# Base Camp Integration Laboratory (BCIL) EES Demonstration RFI

DOE-Sandia / DOD Webinar  
Hosted by: Sandia National Labs

# CAMP Load Profile

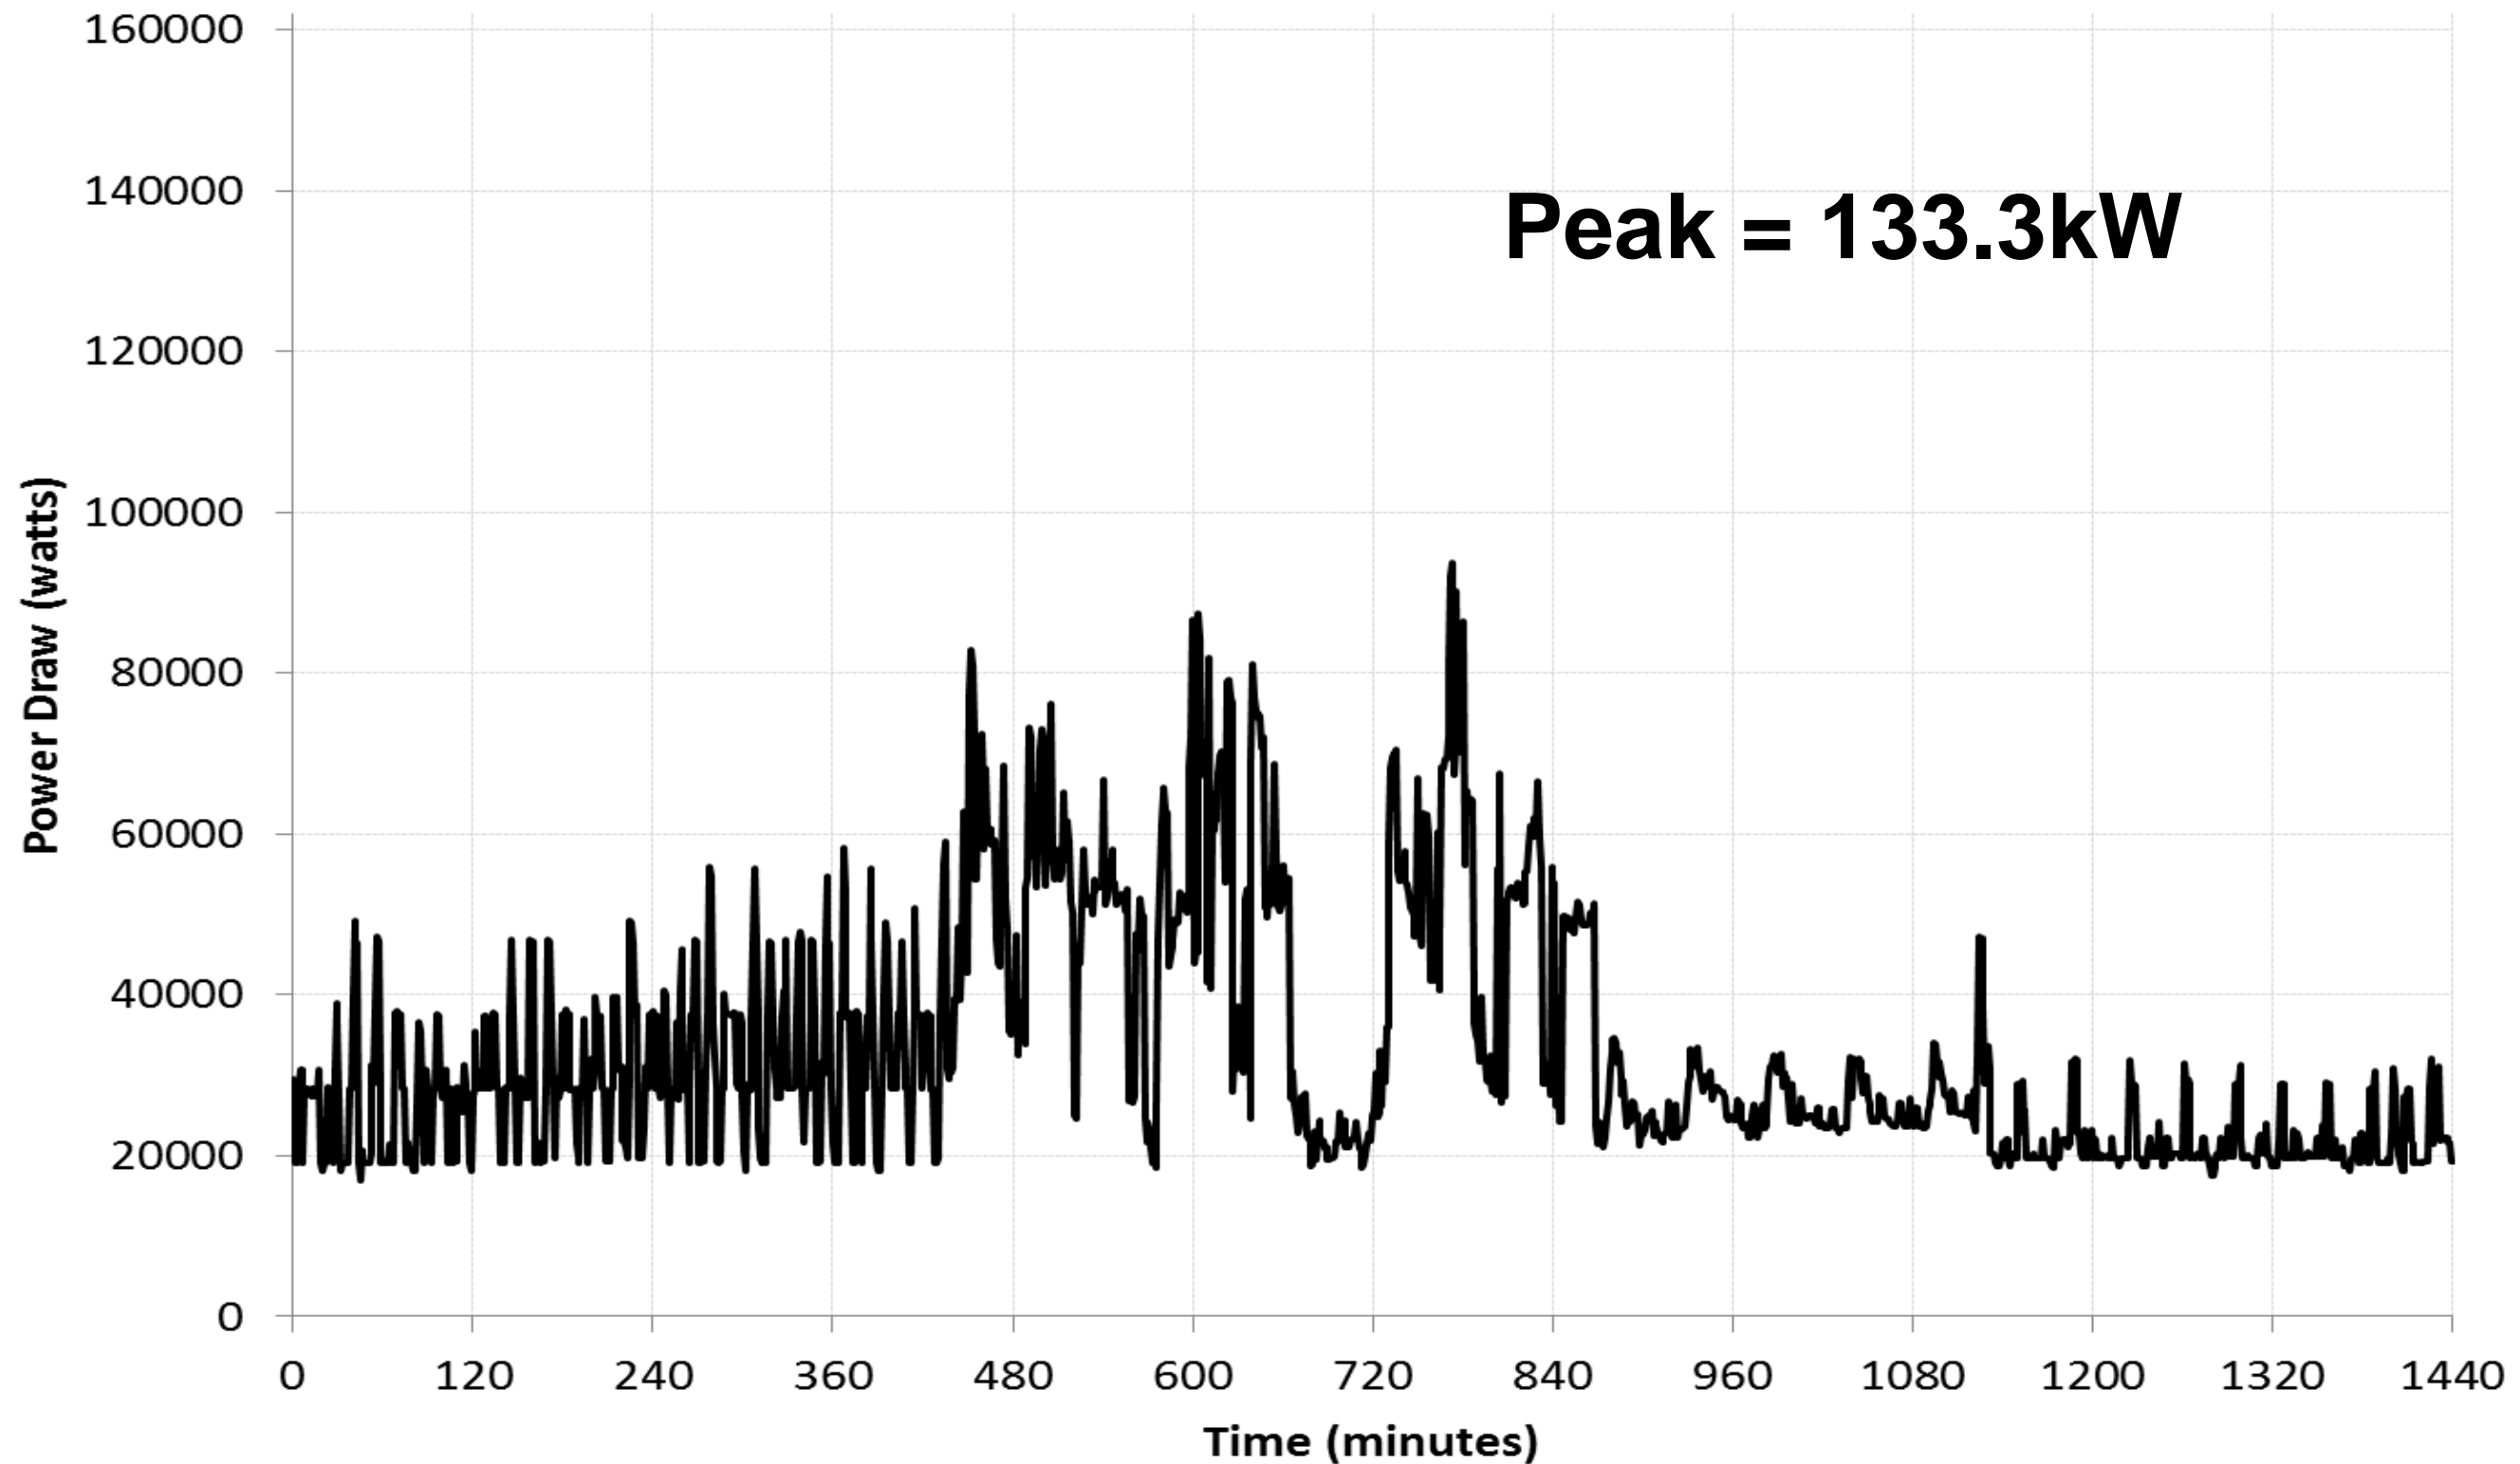
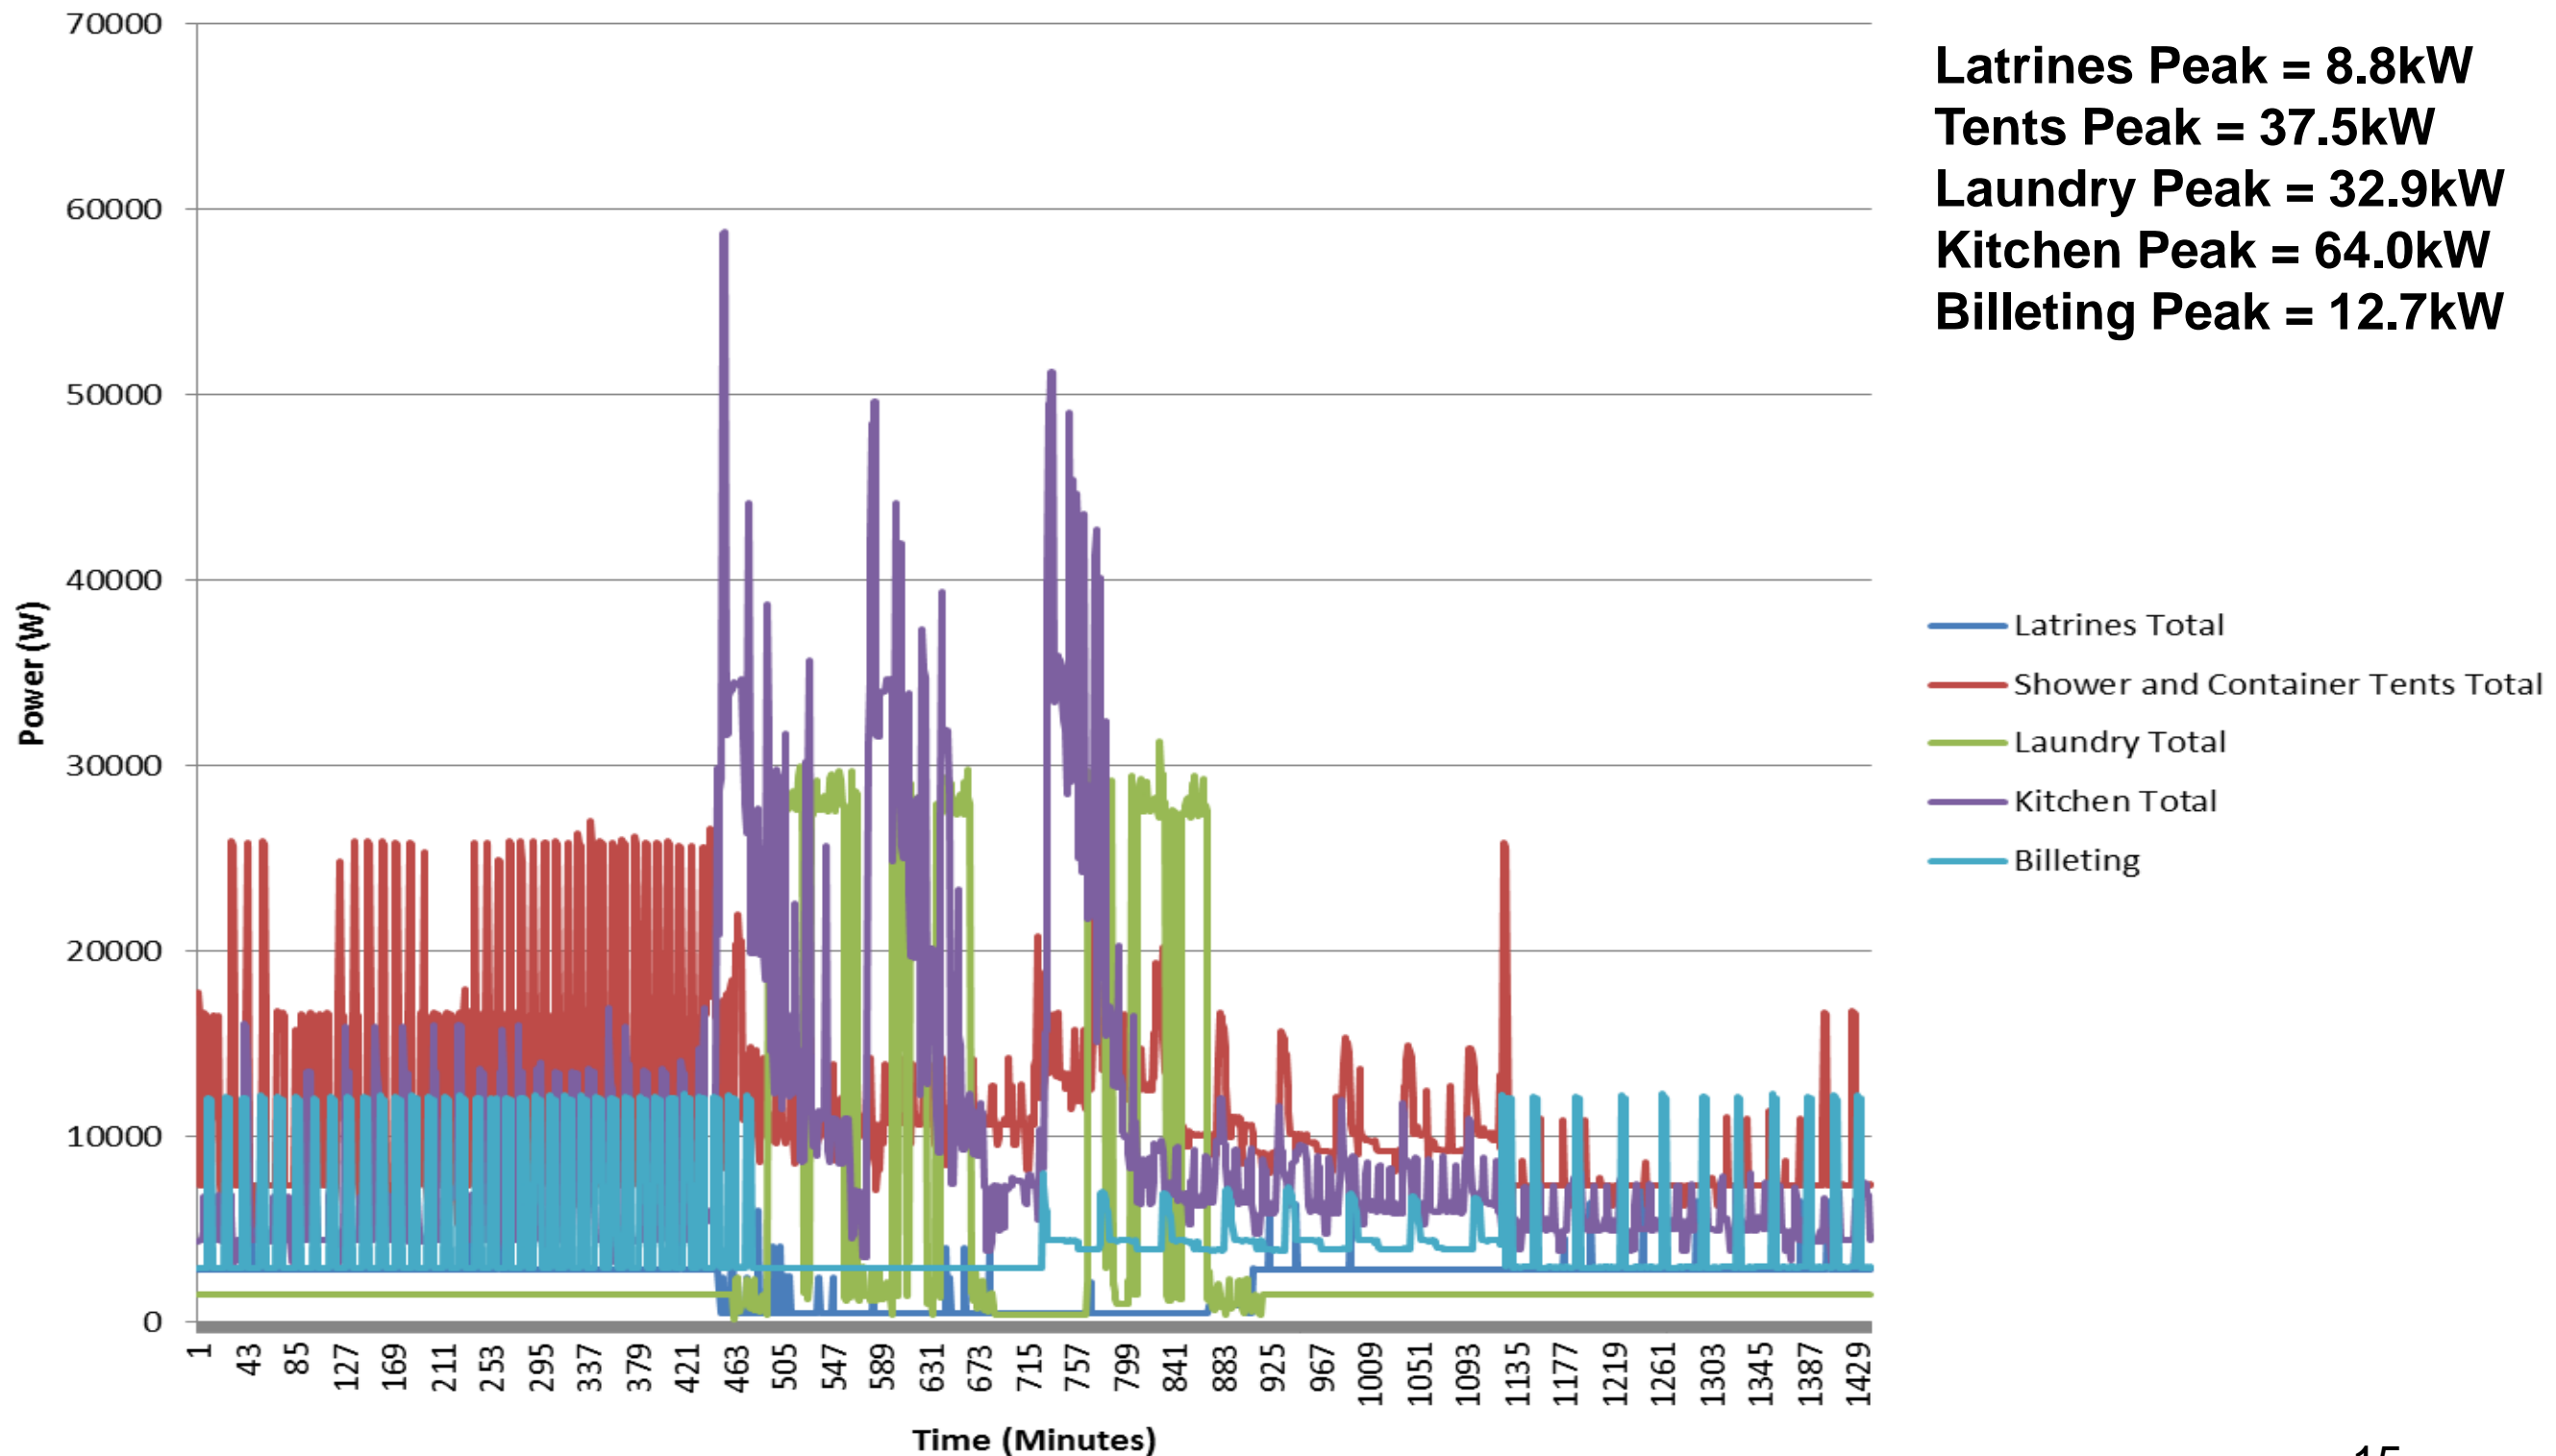
- Is there a load profile for the camp?
  - Yes, there is a simulated load profile for the total camp and the individual feeders. Profile is part of this presentation.
- What is “AC Input”
  - Able to connect to the AC grid and see only the renewable energy for a kind of smoothing application. This can be done with monitoring and controls.
- Why are there size and weight limitations?
  - The Army all-terrain forklift has a maximum capacity of 10K lbs. The Military standard airlift pallet, the 463L pallet, has a maximum weight of 10K lbs. A TRI-CON container efficiently fills one 463L pallet position in a Military Aircraft. Therefore each TRI-CON container must weigh less than 10K lbs, including the weight of the container.
- Can we use multiple tri-con containers?
  - Yes, within reason.
